Appendix A:

Coordination & Correspondence

*Lower Pool 2 Channel Management Study:
Bou langer Bend to Lock and Dam No. 2*

Figure 1 – PFC Sampling Points near Boulanger Bend

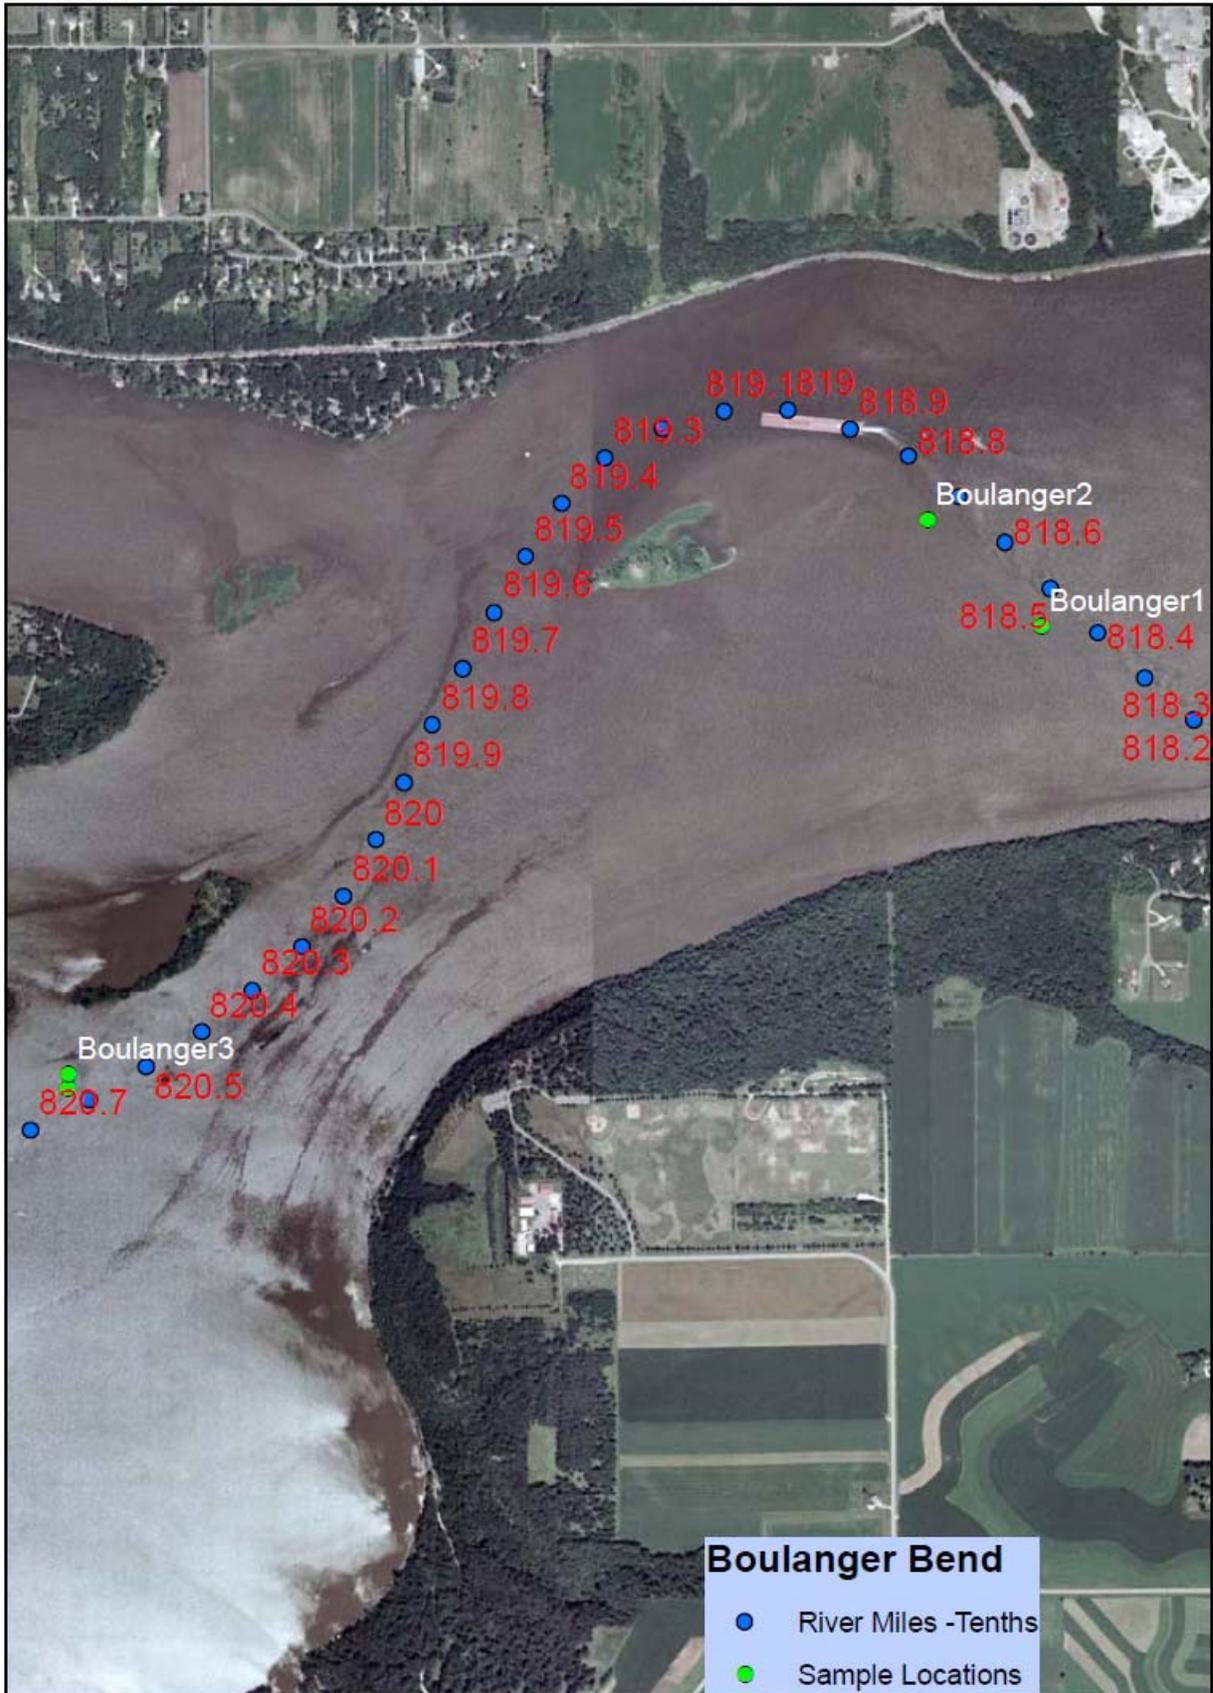
Please clarify if a Federal Environmental Assessment or Federal EIS will be completed for this project. The DNR would like to participate in the development of this document as a reviewer and commenter during scoping and from a technical aspect if such agency participation is being coordinated. Concerns would include but are not limited to how sediment would respond in regards to scouring or sloughing. How would a new channel affect shoreline stability and flood impacts? How would a new channel affect mussel and fish habitat? State-listed species of mussels have been identified in the area. Impacts to these populations should be evaluated. Have hydrologic models been run to determine what may happen to sediment transfer should flow be restored to Grey Cloud Slough or should the Grey Cloud Island Backwater area be cut off if the proposed Nelson Mine Expansion project proceeds?

In regards to potential PFOS/PFOA contamination: although PFOS/PFOAs were not tested during the 2011 sediment sampling of the proposed Boulanger Bend cut-off location, the Corps has been aware of possible contamination in the area and has done previous testing of several locations in lower Pool 2. As part of the Corps' routine channel maintenance program, twenty Upper Mississippi River sediment samples (top 10 cm) were analyzed for PFCs. The samples were collected in October 2008 from channel dredge cuts, harbors dredge cuts and three off-channel locations just below the 3M plant in Cottage Grove, MN (Table 1). The samples were sent to Columbia Analytical, Kelso Washington, for high performance liquid chromatography with mass spectrometry (HPLC/MS) analysis. Each sample was analyzed for 17 different PFC compounds listed in Table 2. The majority of the results were below the detection limit, but perfluorooctane sulfonate (PFOS), which is known to strongly sorb to solids and may be a major sink for PFCs (Higgins et al. 2005), was above detection limits in more than half the samples. From the samples that had measurable concentrations of PFCs, Lake Pepin had the highest detection (5.9 ng/g for PFOS). The three 3M sites had a few measurable concentrations of PFCs, but they were in-line to the levels detected at the boat harbors. Of the four below Lake Pepin samples, only Alma small boat harbor had a quantifiable detection.

Considering the proximity of these 2008 samples to the proposed channel modification project at Boulanger bend (Figure 1), it seems likely that PFOS/PFOA levels at the proposed cut-off are in-line with the 2008 levels for lower pool 2, at least for the surficial sediments where the 2008 samples were collected. However, because the 2008 samples were collected only from the top 10 cm and the proposed cut-off channel would be dredged to 11.5 feet, it may be necessary to collect and analyze samples at depths down to 11.5 ft and below to characterize what sediment will be removed and what will remain as the new sediment surface.
